**SUBJECT: Voluntary Safety Recall Campaign Number 11V-177  
Horizontal Headlamp Adjustment Mechanism**

Department: Service  
Section: Electrical  
Model(s): ALL  
Model Year(s): 2011  
Effective Date: April 9, 2011  
Form #: Recall Bulletin 11V-177  
Rev #: N/A  
Supersedes: N/A

Left side assembly shown in illustration.

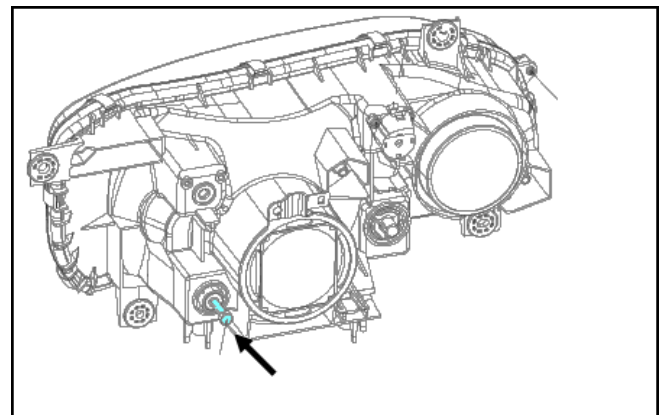
Specific 2011 Model vehicles listed above fail to comply with the requirements of Federal Motor Vehicle Safety Standard No. 108, "There shall be no horizontal adjustment of the low beam headlamp for visually/optical aiming headlamps".

- From the backside of the headlamp assembly, locate the horizontal adjustment screw. This will be on the outboard side of the headlamp capsule.

All subject vehicles within the above VIN breakpoints will have a prevention cap installed over the low beam horizontal headlamp adjustment mechanism.

- Install the plastic prevention cap over the horizontal adjustment screw as illustrated:

**NOTE:** When installing the caps, push firmly until it clicks into place.
